Coast Star Letter

Objections Sent to Public Hearing Aug 16 2024

SaveLBI Comment Letter

Figure 2-2: Visibility Metrics levels at Brigantine Wilderness Area

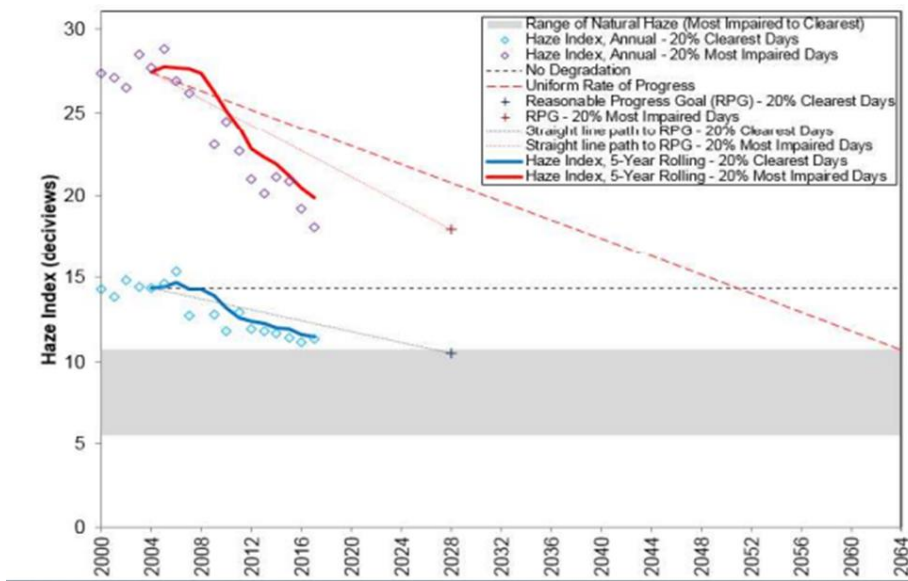
- Figure 2-2 of the New Jersey Regional Haze SIP shows that the projected 2028 visibility at the Brigantine Wilderness Area is well below the URP level. Additionally, the figure indicates that the observed 2016 visibility at Brigantine is approximately 6 deciviews below the URP glide path. The average observed visibility from 2018-2022 (see figure below) shows more than 6 deciviews below the URP glide path. Therefore, any potential increases in visibility degradation at Brigantine due to the project would not endanger Brigantine's visibility remaining below the URP glide path and meeting the regional haze rule goals.

The calculated URP line is drawn for the most impaired visibility days only. USEPA recommended in its draft guidance that states recalculate the value of the 2000–2004 baseline, or use an updated value provided by USEPA or the IMPROVE program. Figure 2-2 shows that Brigantine Wilderness Area is well below the 2018 URP level for the first SIP Planning period and currently below the 2028 URP level for the second planning period.
